The Commission has issued the enclosed Amendment No. 5 to Facility License No. DPR-66 for the Beaver Valley Power Station, Unit No. 1. This amendment is in response to your request dated March 24, 1976.

ATTACHMENT TO LICENSE AMENDMENT NO. 5

BEAVER VALLEY POWER STATION UNIT NO. 1

Amendment No. 5  
License No. DPR-66

**FIGURE 3.1-2 THE PLANT WATER INTAKE STRUCTURE**

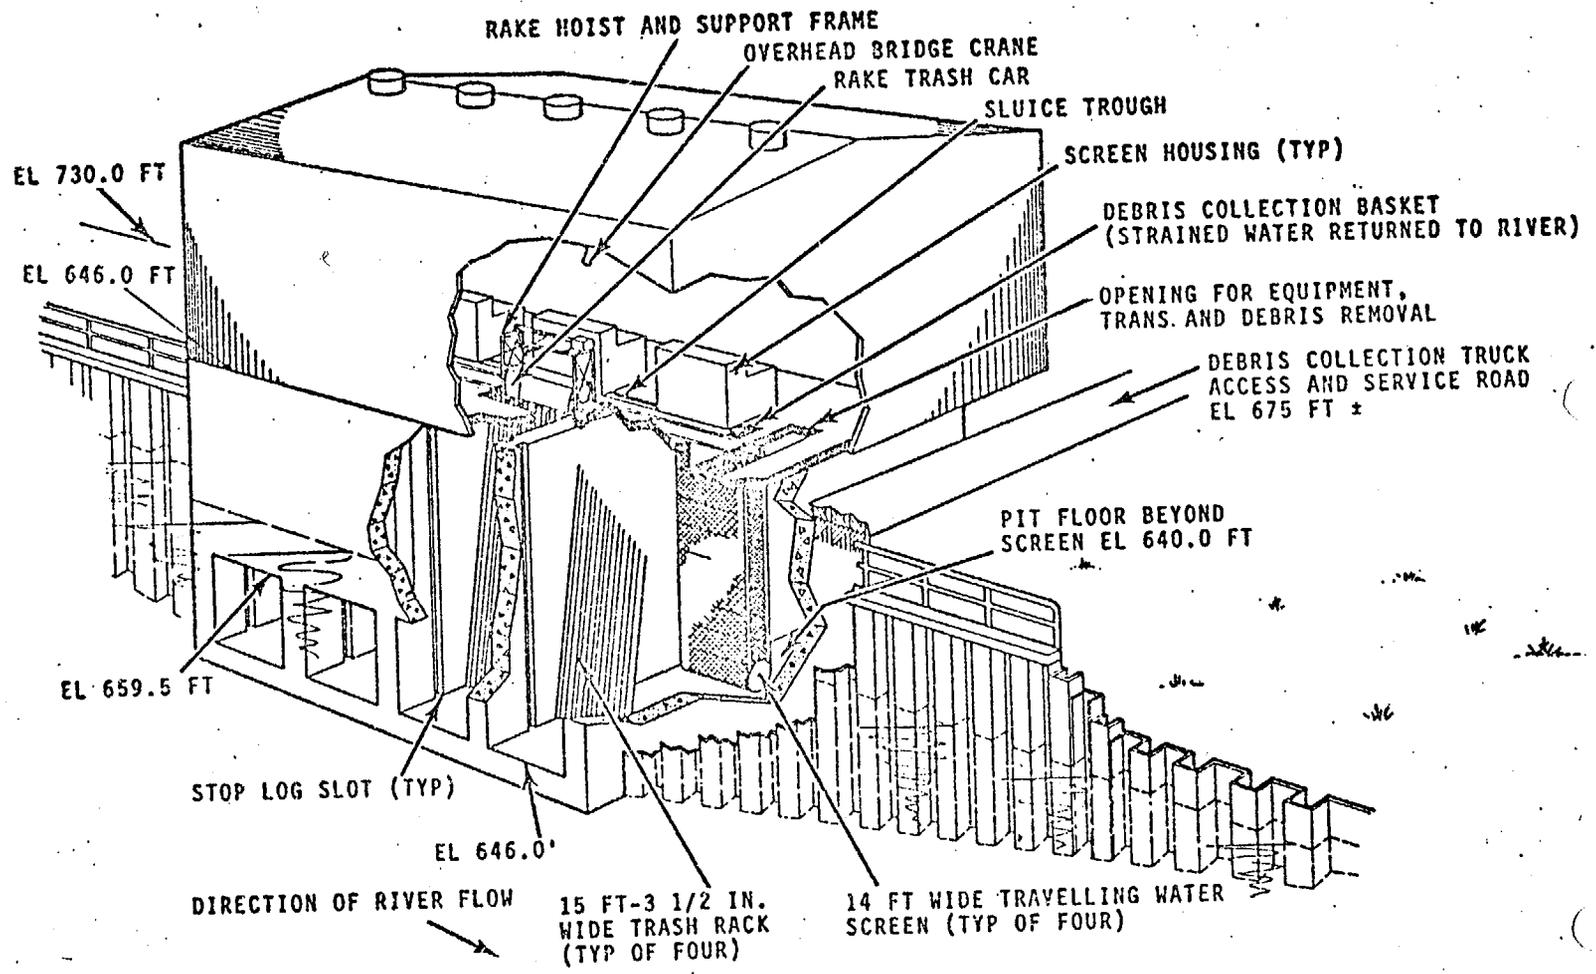
Intake samples (Figure 3.1-2) shall be collected at each operating intake bay by making a number of vertical plankton net hauls to encompass the width of each operating intake bay. River samples shall be collected by making a number of stationary plankton net collections at five equidistant locations and several depths along the transect.

Figure 3.1-3  
 BVPS Intake Structure

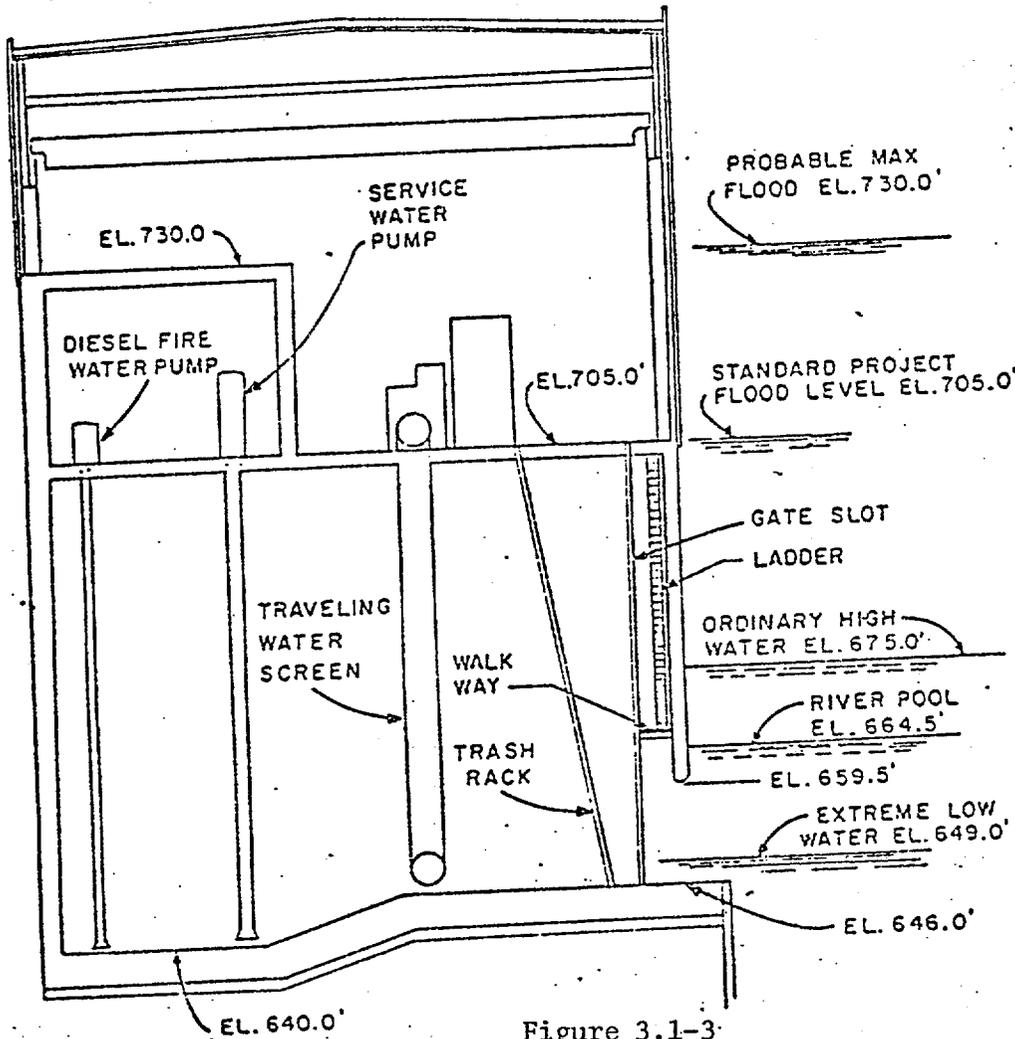
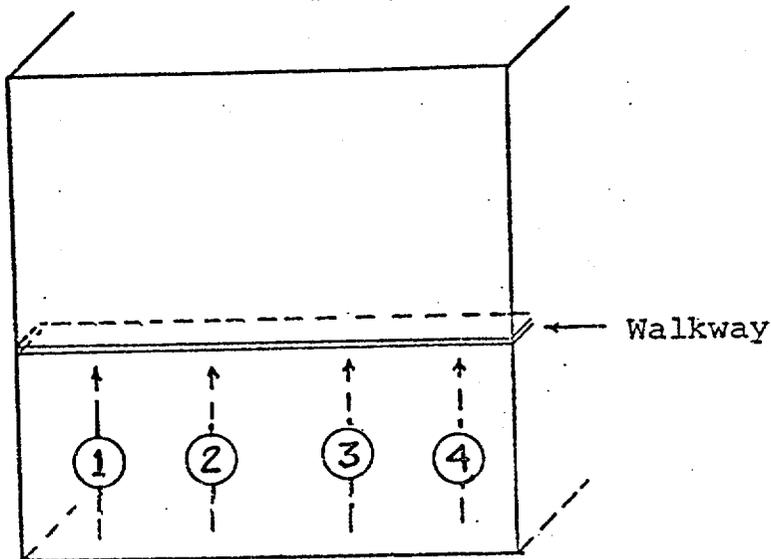
Intake samples shall be collected from a walkway which crosses the width of each intake bay (Figures 3.1-3 and 3.1-4). A composite sample at each operating intake bay shall be collected by making plankton net (Size 505 micron, one meter) vertical hauls. The number of hauls shall vary depending on the water depth in the bay. A total volume of approximately 75 cubic meters of water will be sampled. This volume is based on a 100% filtration efficiency of the haul.

Each composite sample shall consist of an equal number of hauls made at four locations across the width of each sampled bay (Figure 3.1-4). Hauls at locations 1 and 4 shall be made simultaneously and hauls at 2 and 3 simultaneously. For example, a typical procedure follows:

FIGURE 3.1-5

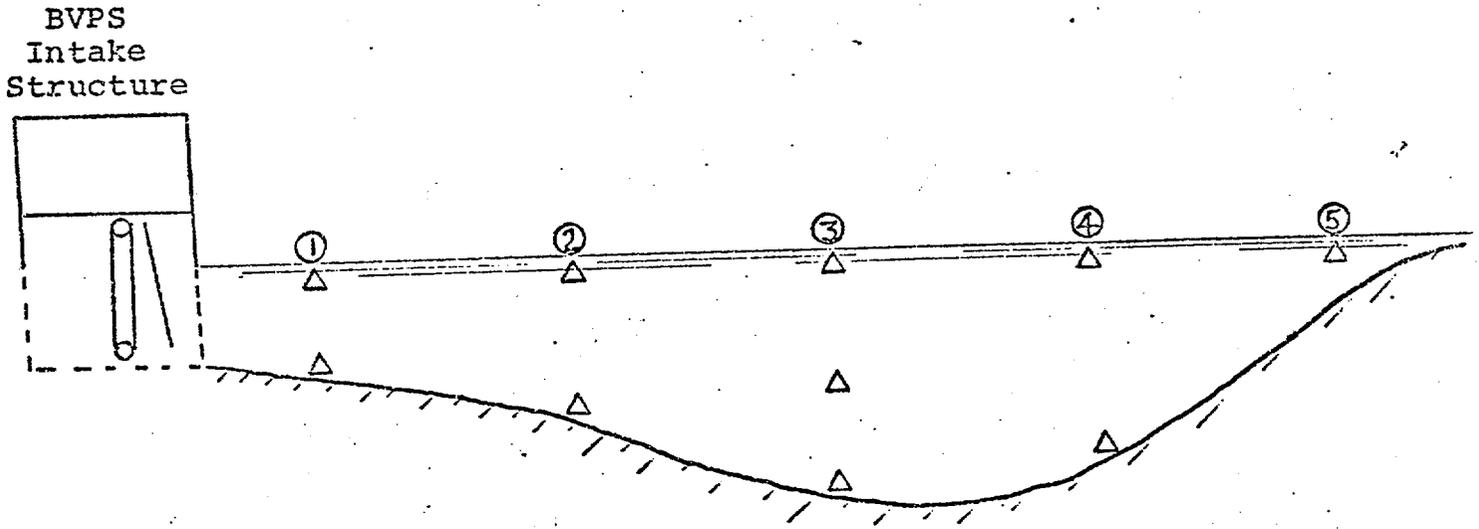
River samples shall be collected at five locations and several depths along a transect crossing the river in front of the intake structure (Figure 3.1-5) and within the same time frame as the intake day and night sample collections.

A total of ten samples shall be collected for the day set of samples and 10 for night set of samples by making 2 to 5 minute stationary plankton net hauls.
